## NNA14489731Q-AMD – Amendment 2

### Questions and Answers

**TAB DESIGN X (4 OW/4X2 PW)**

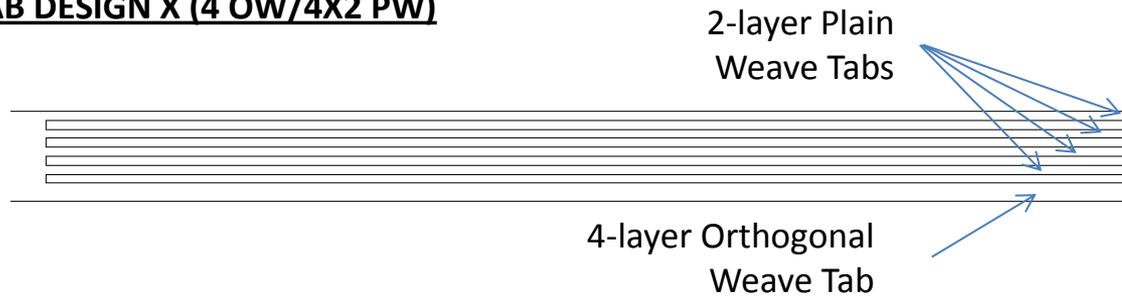
2. What is meant by 10 layers "incrementally" stitched in the description for the optional task? Description makes it difficult to price.

Incremental stitching in this case would be the stitching of tabs that are composed of 1-4 layers of carbon weave. There could be as many as 10 tabs on the edges of each carbon fabric panel. The concept is to stitch adjacent tab layers where two carbon fabric gore panels intersect (lap seam) in order to design a robust seam capable of withstanding the aerothermal heat pulse. When the top stitch layer ablates away, the next layer below would still be intact. A simplified schematic is attached to illustrate the concept further. Other proposed embodiments of the incremental stitched concept are welcome, but perhaps requires a better understanding of the end use application, weaving limitations, and better defined requirements.
